ACCESSION NBR: 8601150046 DOC. DATE: 86/01/07 NOTARIZED: NO DOCKET #
 FACILITY: 50-305 Kewaunee Nuclear Power Plant, Wisconsin Public Service 05000305
 AUTH. NAME: HINTZ, D. C. AUTHOR AFFILIATION: Wisconsin Public Service Corp.
 RECIP. NAME: LEAR, G. E. RECIPIENT AFFILIATION: PWR Project Directorate 1

SUBJECT: Forwards addl info re inadequate core cooling instrumentation, including revised sys description & revised error analysis, in response to NRC 850522 request. W/one oversize drawing.

Docket 50-305
Operating License DPR-43
Kewaunee Nuclear Power Plant
TAC #45143
Inadequate Core Cooling Instrumentation

Response to the Request for
Additional Information
Dated May 22, 1985

FIGURE 1
ICC MONITORING SYSTEM

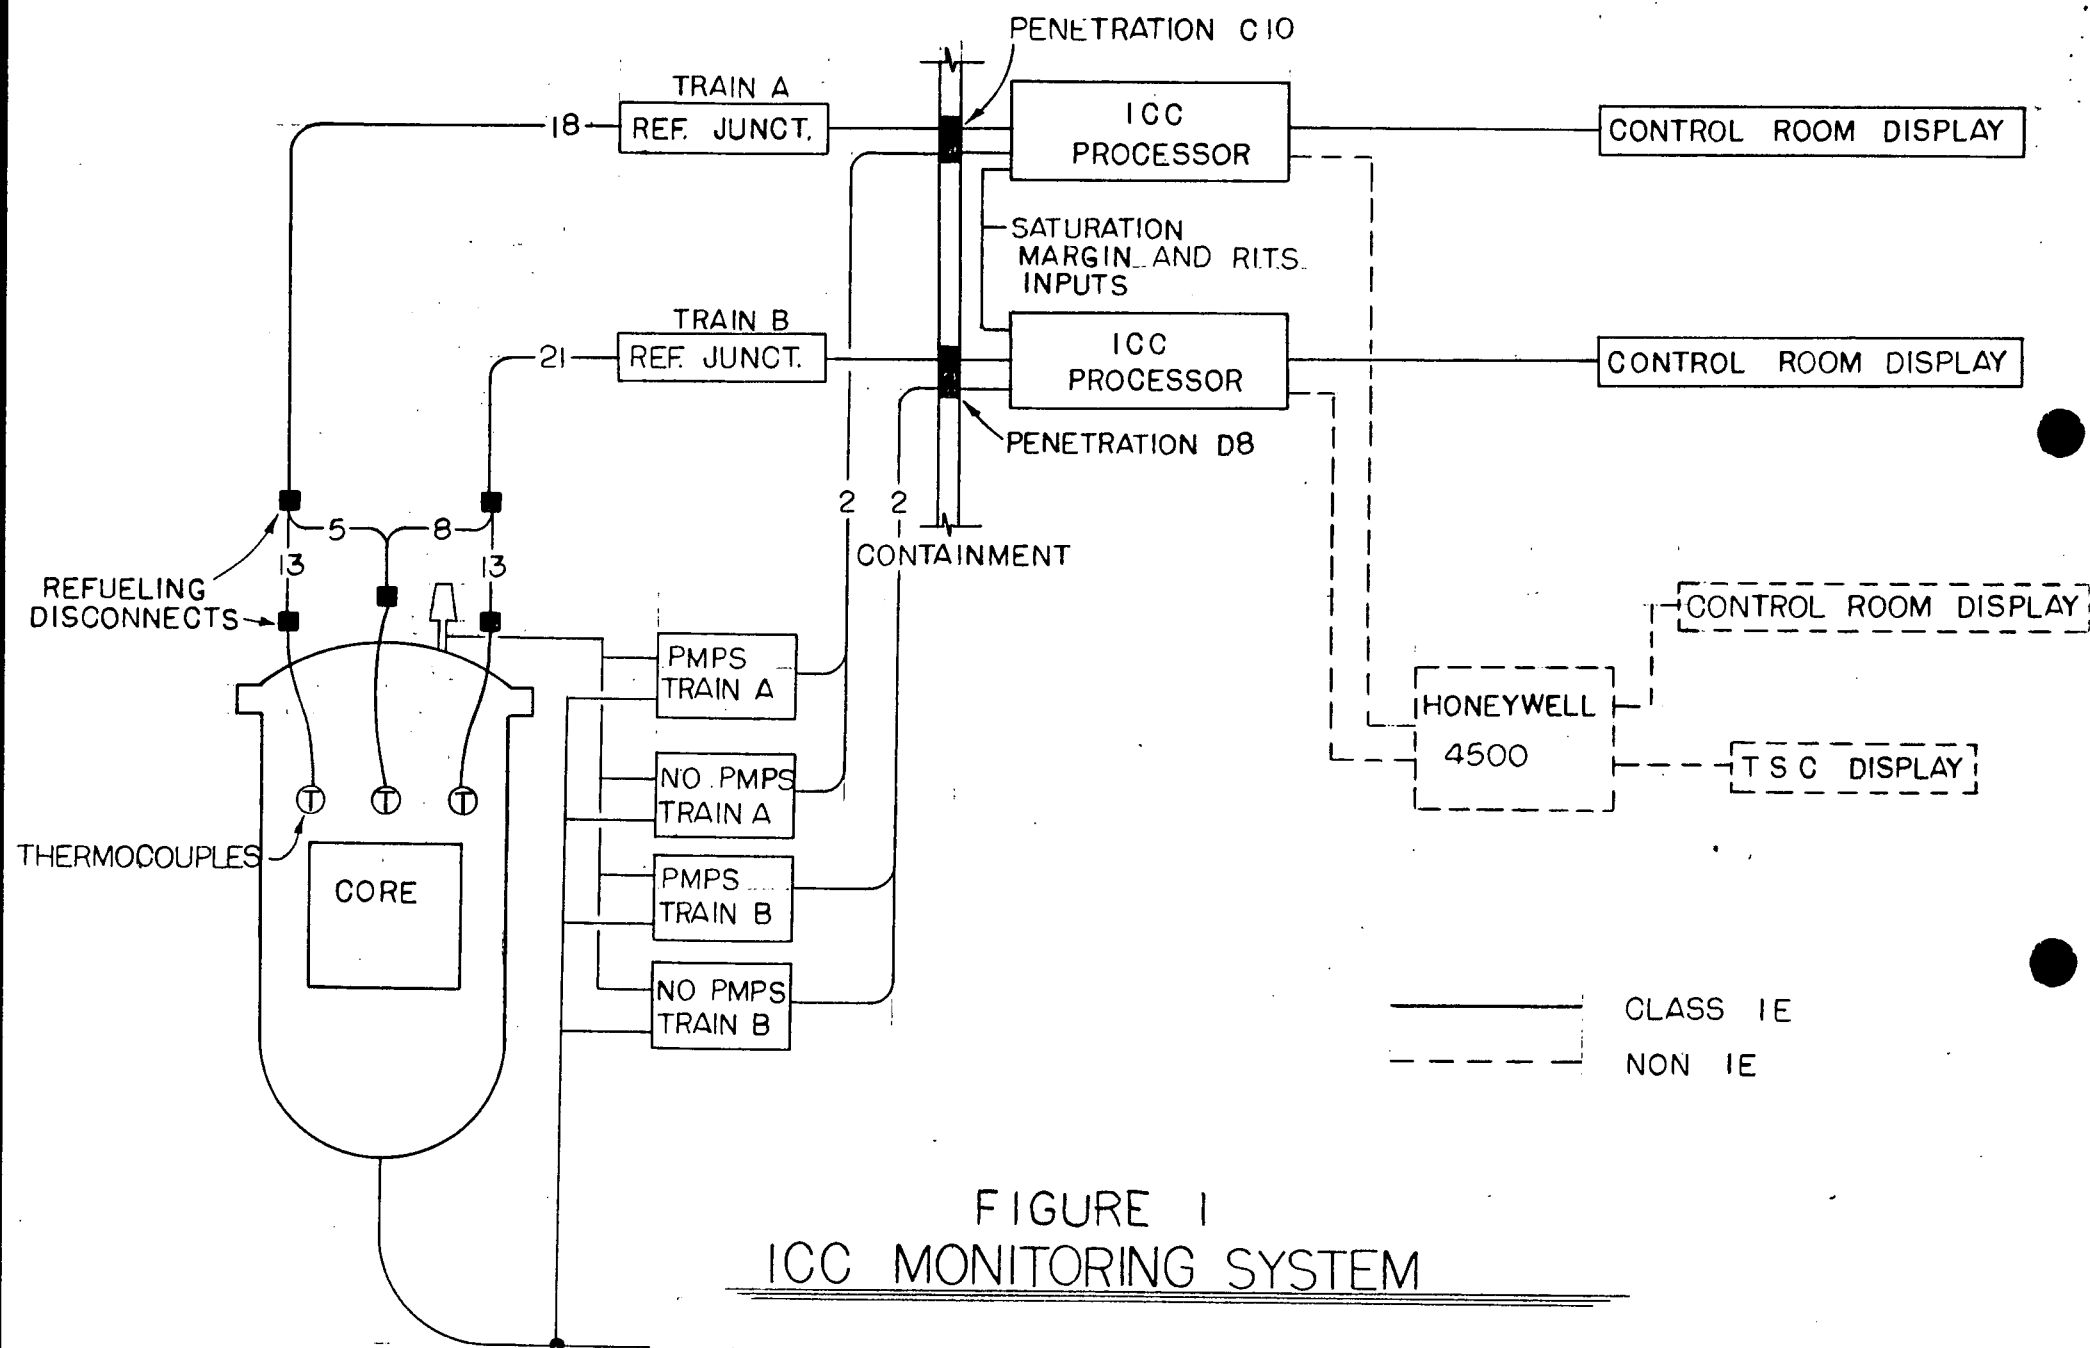
1. Elaborate on the indications of the reduced flow and full flow transmitters during various flow conditions (e.g. 0, 1, 2 pumps running).

2. Explain the full flow suppression technique and the expected indications with various void fractions or equivalent collapsed vessel water levels.

The reduced flow transmitters have been renamed the "Pumps Off" transmitters and are utilized during zero pump operation. The full flow transmitters have been renamed the "Pumps On" transmitters and are utilized during one or two pump operation.

Refer to attached drawing WSK146 Revision 3 for the Control Room indication of the RITS system. The indication for a "Pumps Off" situation will be found on the redundant "RXCP 1A and 1B Off" meters associated with the Reactor Vessel mimic. At this condition, the "RCS VOID FRACTION %" trend recorder will be driven off scale low. The indication for "one or two pumps on" is provided by the "RCS VOID FRACTION %" trend recorder. At this condition, the "RXCP 1A and 1B OFF" meters will be driven off scale low. The void fraction trend recorder is scaled from -100 to +200 and is to be used as a trending device only.

The expected indications are as follows: During normal operating conditions with both Reactor Coolant Pumps running, the "RCS VOID FRACTION %" trend recorder will show approximately a 0% void fraction. The "RXCP 1A and 1B OFF"

will be driven off scale low. During no pump operation (e.g. post LOCA), the "RCS VOID FRACTION %" will be driven off scale low and the "RXCP 1A and 1B OFF" meter will indicate the collapsed vessel water level.

Full flow suppression occurs in the microprocessors. Here, the differential pressure sensed by the transmitters is compensated for the number of pumps operating (one or two). The compensated display signal is then sent to the "RCS VOID FRACTION %" trend recorder.

FIGURE 1

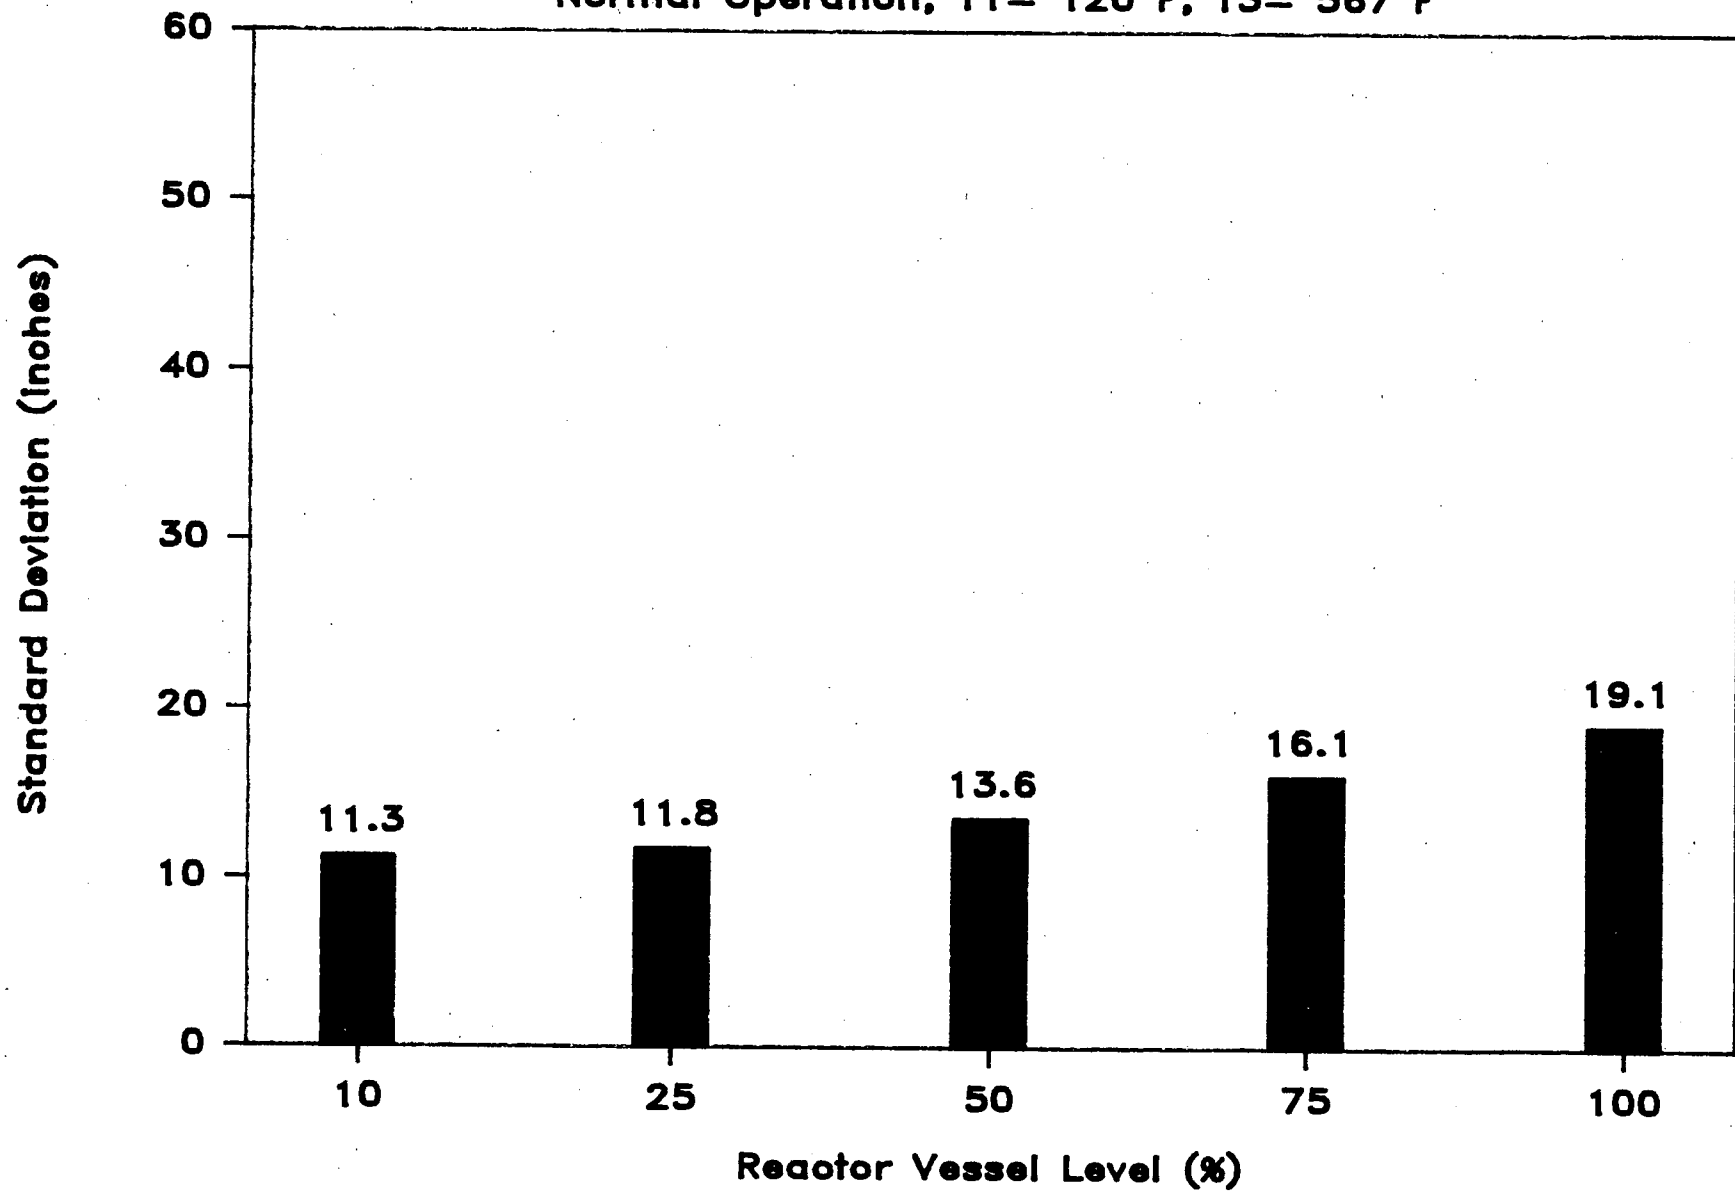
13. During LOCA conditions, the total uncertainty is estimated as ± 26 " for vessel level approaching recovery. However, at vessel levels close to full the

uncertainty seems to be larger. Please indicate the uncertainty during LOCA conditions at levels other than at the top of the core.

See the attached uncertainty analysis.

During normal operating conditions, the total system uncertainty for the Reactor Vessel Level System is ± 19.1 ". During the most severe LOCA conditions, the total system uncertainty is ± 27.4 " for vessel level approaching core uncover. See Figures 1-3 for additional detail.
